Filing Receipt

Control Number - 60319

As a land-owner, full-time resident, and owner/operator of multiple businesses in Hueco Mountain Estates, I am writing to formally log my protest regarding the proposed routes for El Paso Electric's Pine to McCloud 345 kV Transmission Line. I strongly protest the construction of a transmission line along Link 1R through our valley. While I have numerous reasons to oppose this transmission line, I will only focus on one of them. I could discuss the historical significance of the region, with Hueco Tanks State Park and Historic Site located only two to three miles from the proposed route. The fact that people have called this location home for around 10,000 years, and still do. Or I could talk about the many species of animals that live here, migrate through here, and depend on the natural resources here for survival. Maybe I could espouse the beautiful scenery, the mostly undeveloped land, the grand views, the quiet solitude. Perhaps I could argue that there appears to be zero local benefit to this new transmission line which will actually draw power away from our neighborhood's substation—a system where I have already had to file past complai

Figure 3
MRS Site Location Map

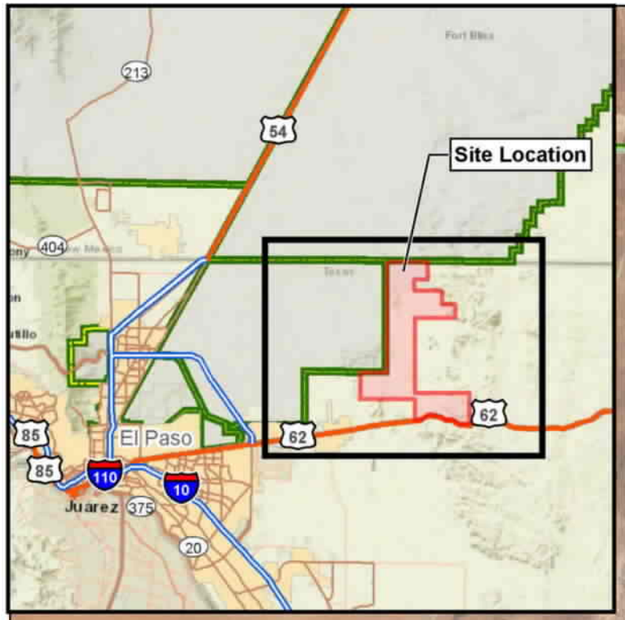
The Army's formal site designations out here include FTBLS-002-R-01 (Former Maneuver Area A), FTBLS-002-R-03, FTBLS-002-R-04, and FTBLS-002-R-05. Link 1R is ***the only*** proposed route that recklessly cuts through the 72,520-acre high-risk zone of FTBLS-002-R-01 and possibly through the high-hazard subsurface zone of FTBLS-002-R-03.

Per the U.S. Army's Feasibility Study, ***subsurface removal and surface clearance of explosives*** are mandated requirements for these exact sectors due to the persistent threat of high explosives. The heavy civil engineering required for 345 kV tangent steel monopoles—specifically deep foundation drilling, heavy transport vibrations, and grading—poses an immediate, catastrophic risk of triggering an accidental detonation. Furthermore, as established by the Department of Defense, shifting desert soils and erosion continually unearth deeply buried ordnance. A route that El Paso Electric claims is "clear" during
